3434 Central Street
Kensington School

Planned Development
22PLND-0012

Memorandum

Subject: Planned Development
3434 Central Street, 22PLND-0012

3434 Central Street - site plan

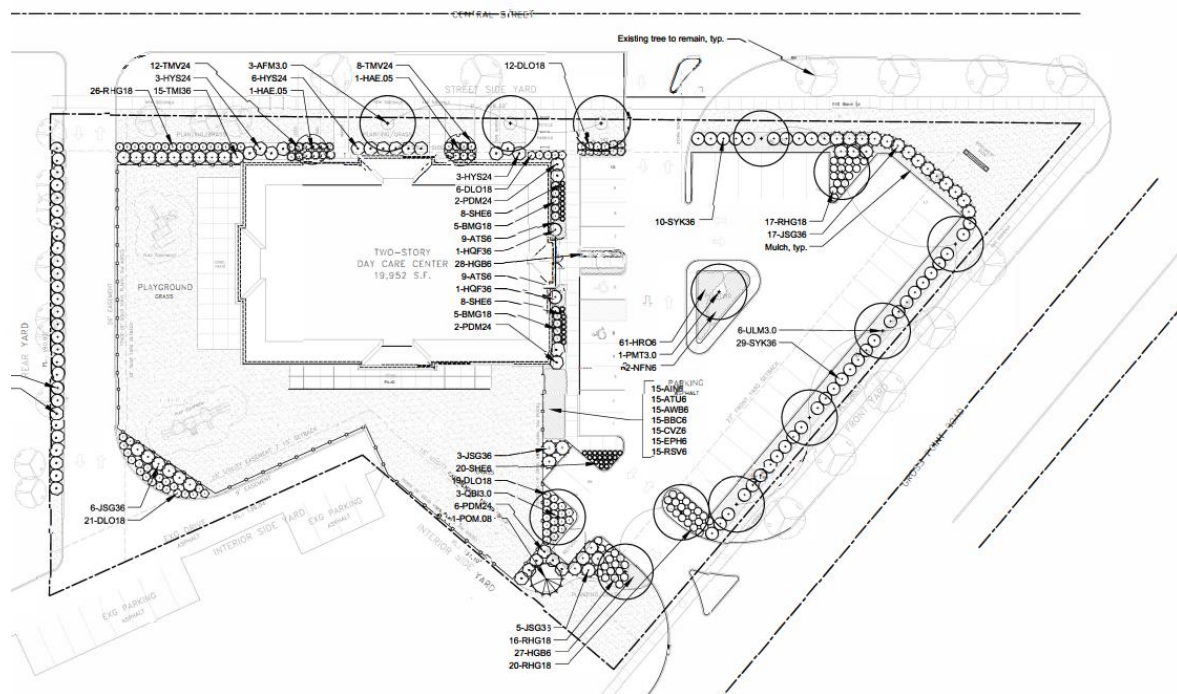
The proposed site plan places the building in the center of the property with playground areas on the west side and the parking lot on the east side of the site. The applicant provided and staff reviewed several site plan layouts and the one proposed was determined to be the best site plan in terms of the parking lot and playground locations and on-site circulation.

The parking lot contains 35 parking spaces, including 2 ADA accessible parking spaces and provides space for caretakers and parents to drop-off/pick-up their children and for staff parking. The number of parking spaces provided complies with the zoning code.

Bike parking is shown at the northeast corner of the building, near the main entrance. At staff's request, the bike parking area appears to be able to accommodate cargo and trailer pull behind bikes. Specific details can be reviewed at the time of a building permit review.

The refuse enclosure is located to the south of the building and screened by a 6-foot tall masonry enclosure. The materials include red face brick, gray limestone, and a white steel gate.

A 6-foot tall solid white vinyl fence is shown enclosing the areas west and south of the building, including the playground area.

The site plan notes a monument sign near the northwest corner of the site. Signage requires a separate permit from a building permit.

DRAWING NO.
A1-0

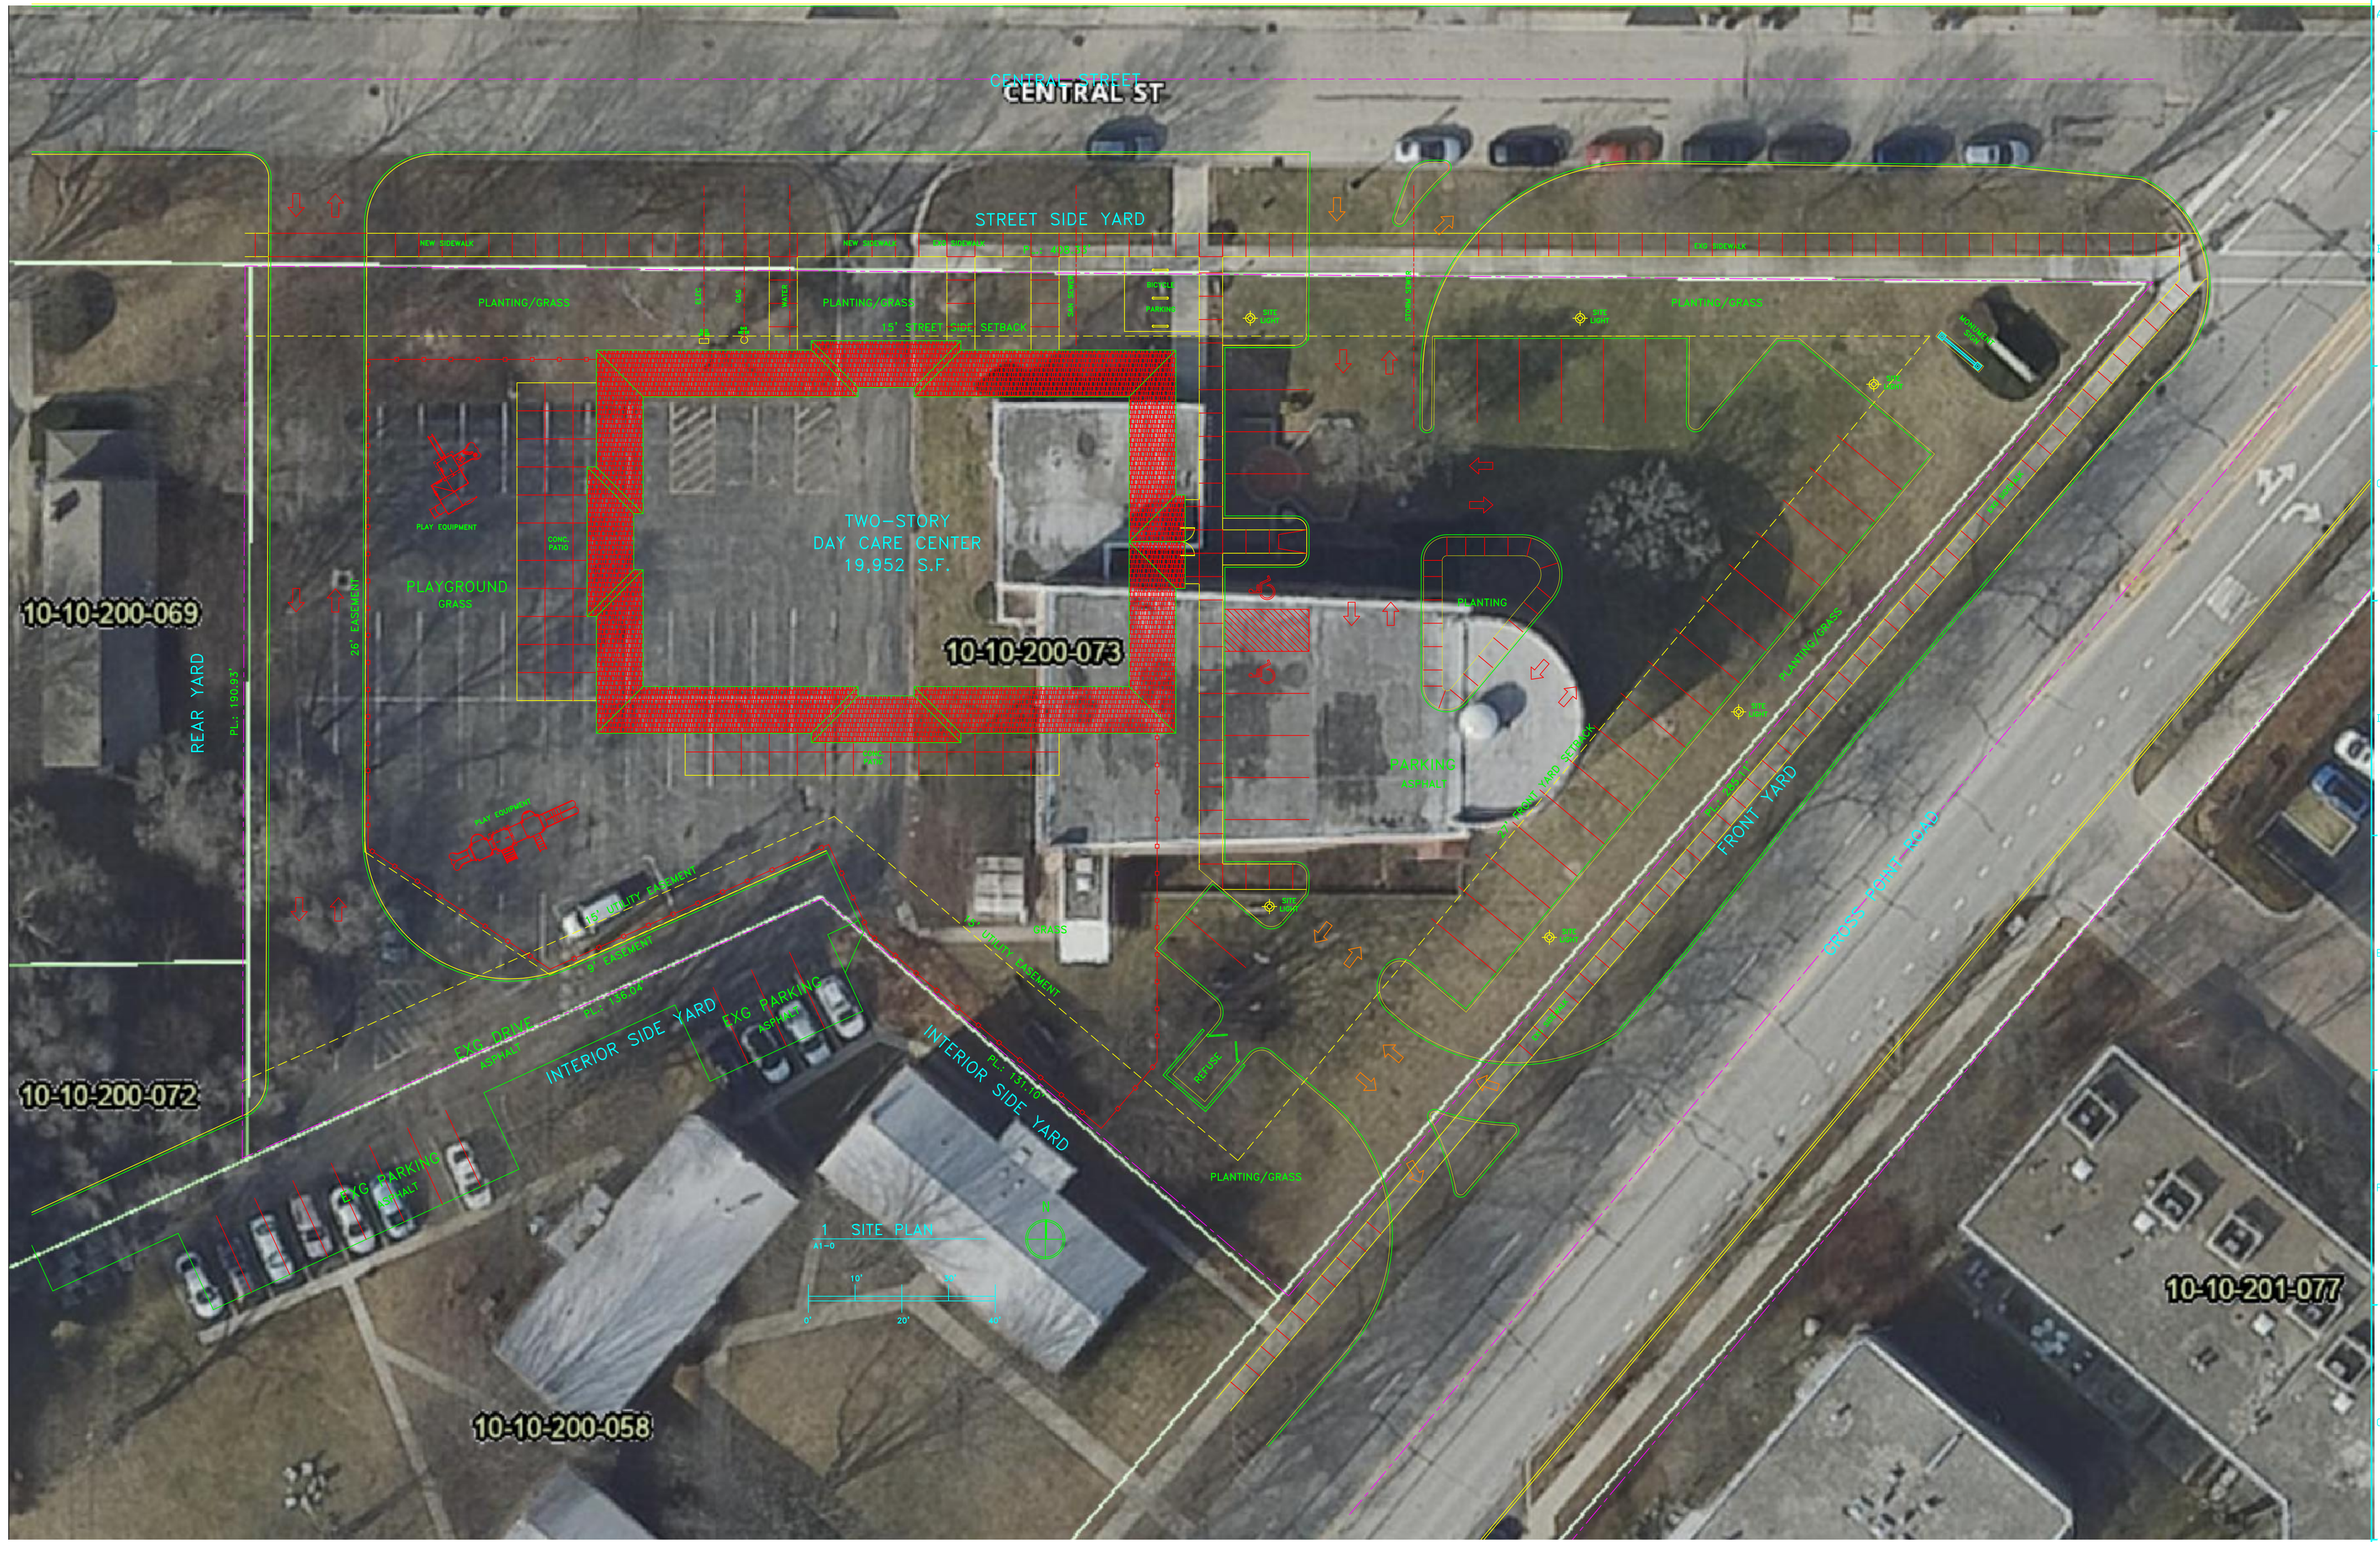
Two-way drive aisles are required to be at least 24-feet wide. The plan provides a 20-foot wide driveway serving the Co-Op and a 17-foot wide drive aisle adjacent to the Co-Op's existing parking spaces which maintain existing conditions. The drive aisles within the parking lot serving the daycare center are 24-feet wide.

- Staff are not allowed to park in the neighborhood.
- Provide access to maintain trees and plantings along the west property line. *Revised site plan provides access to trees and plantings along the west property line.*

- Provide a minimum 20-foot wide driveway off Central Street to the Co-Op parking.
- Water and sanitary sewer service to the Co-Op needs to be relocated since current lines are impacted by the proposed building location. *Details for utility connections can be reviewed at the time of a building permit review.*

0' 10' 20' 60'
NORTH SHEET NUMBER
L1.0

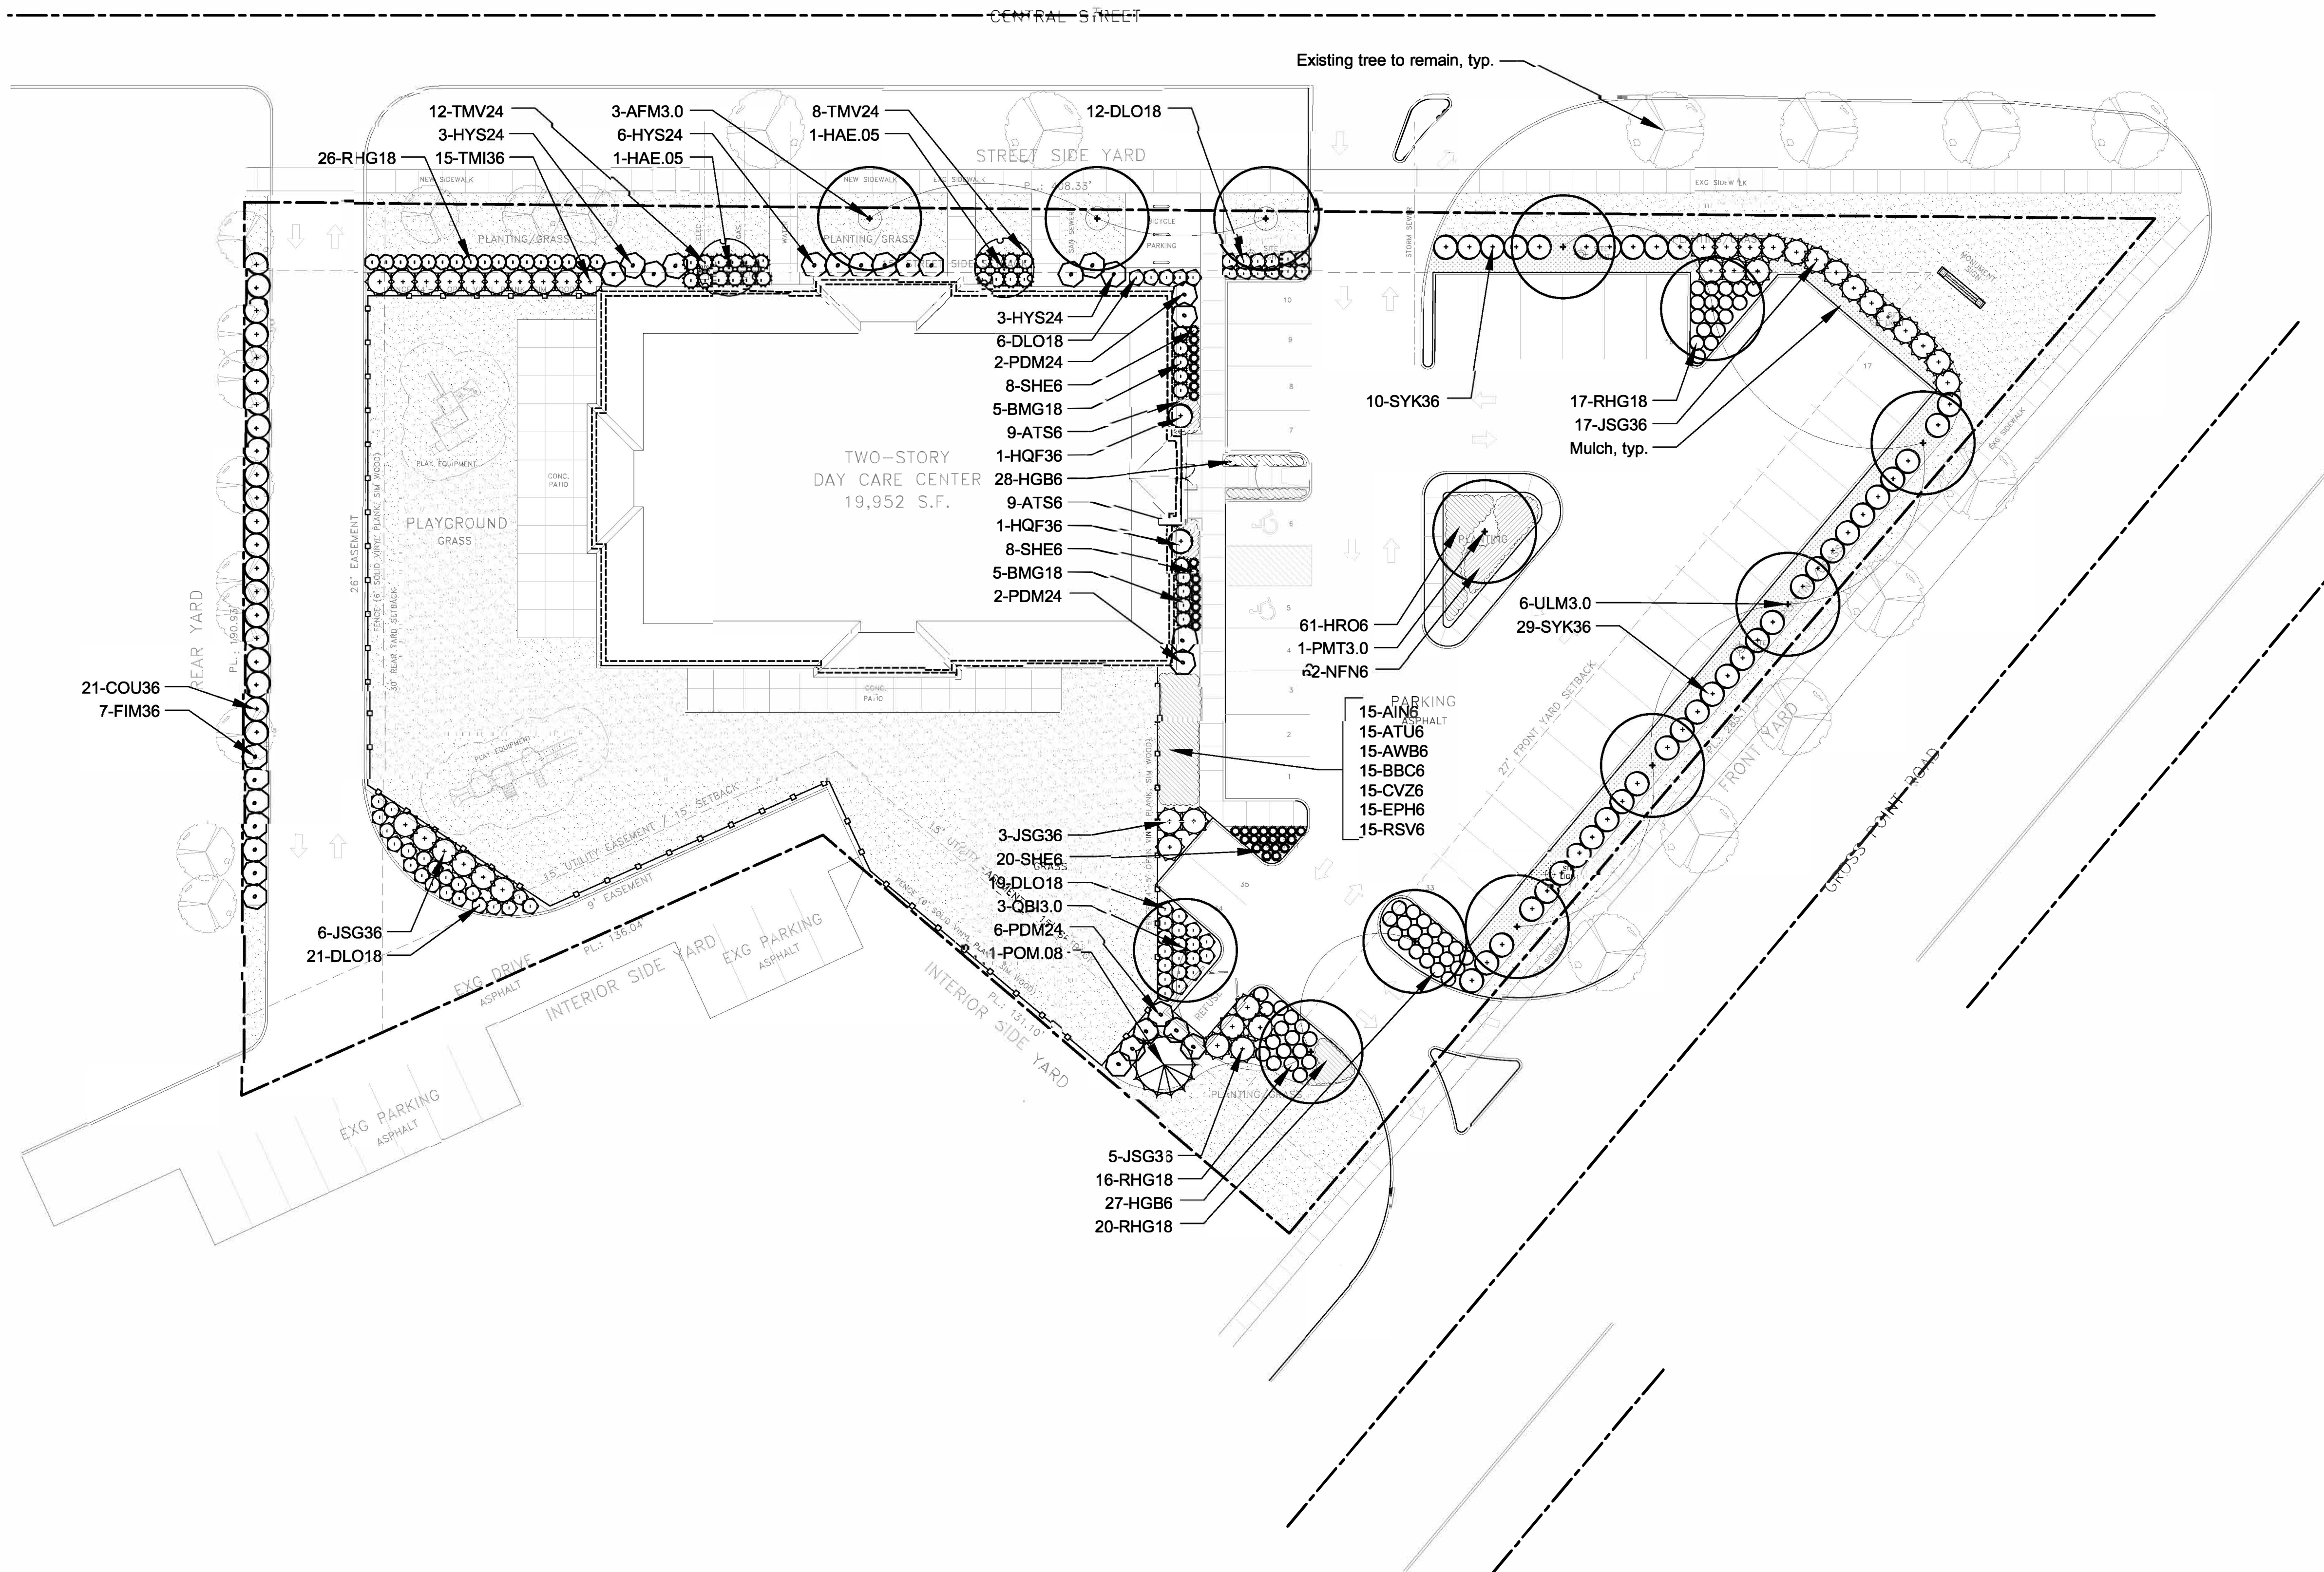
A 10-foot wide transition landscape strip is required along the west and south sides of the site. The plan does not provide the required 10-foot wide landscape strip; however, landscaping is provided within a 6-foot wide strip between the west property line and the north/south driveway for the Co-Op and at the southwest corner of the playground area,

While the required 10-foot wide transition landscape strip is not met along both the west and south property lines, the plan provides a 6-foot wide landscape strip along the west property line to screen the proposed driveway serving the Co-Op and a 6-foot tall privacy fence enclosing the playground and yards to the west and south of the building to screen the daycare center’s activities. As proposed, the plan provides the intended screening between the proposed non-residential use and existing residential uses.
